RESPONSE TO REQUEST FOR ADDITIONAL INFORMATION

APR1400 Design Certification

Docket No. 52-046

RAI No.: 407-8447
SRP Section: 19.03 – Beyond Design Basis External Event (APR1400)
Application Section: 19.03
Date of RAI Issue: 02/17/2016

Figure 1 Locations for SFP FLEX pump connection

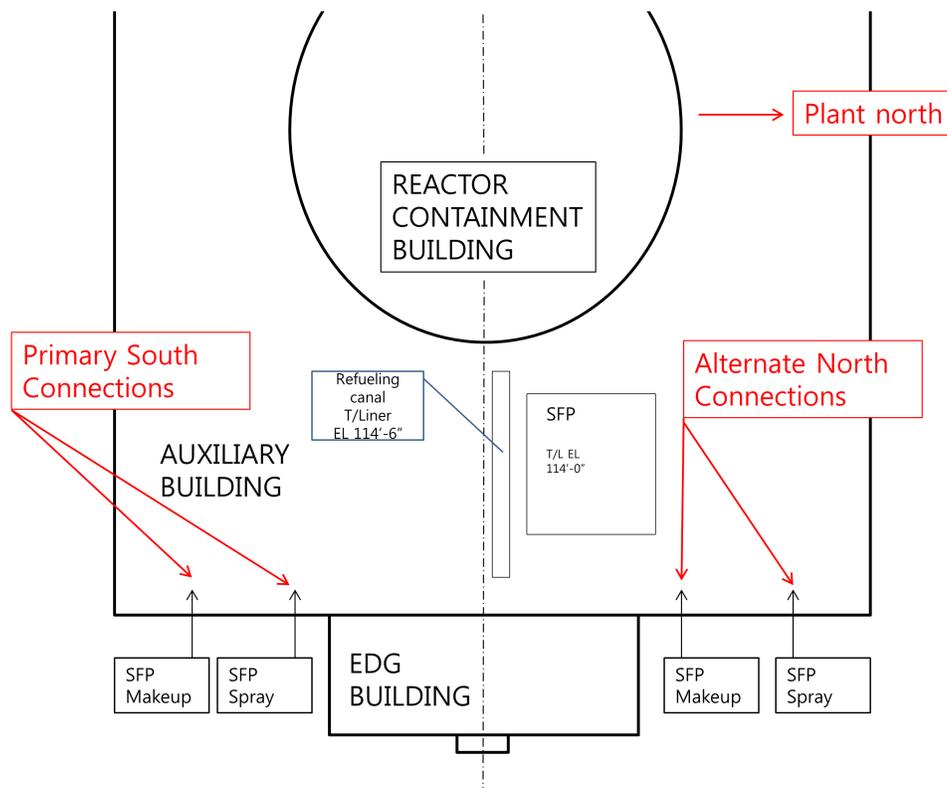
The staff reviewed the information in APR1400-E-P-NR-14005-P, "Evaluations and Design Enhancements to Incorporate Lessons Learned from Fukushima Dai-Ichi Nuclear Accident," Section 5.1.2.4.1.2, comparing it with the NEI guidance. It is not clear whether the connections being used in the proposed mitigation strategies for SFP cooling are consistent with the

guidance that the location of the connection points should provide reasonable assurance of at least one connection being available for all applicable external hazards.

The applicant is requested to clarify how the APR1400 design for connections to the FLEX equipment is consistent with the NEI guidance.

The APR1400 mitigation strategy for SFP cooling is schematically illustrated in Figures 6-2 and 6-3, and the approximate locations for makeup water connections are indicated in Figure 6-4. The APR1400 design provides two locations for SFP makeup water connections: a set of two primary connections (one for makeup and one for spray) is mounted on the outside wall of the Auxiliary Building (AB), adjacent to the south side of the Emergency Diesel Generator (EDG) building; and the alternate set of identical connections (one for makeup and one for spray) is mounted on the outside wall of AB, adjacent to the north side of the EDG building. Please refer to Figure 1 below for illustration.

Since the south and north connections are physically separated by the EDG building which is a seismic Category I reinforced concrete structure and also designed to withstand the effects of internal and external hazards. This configuration provides reasonable assurance of at least one connection being available; and is consistent with the guidance in Section 3.2.2 of NEI 12-06.
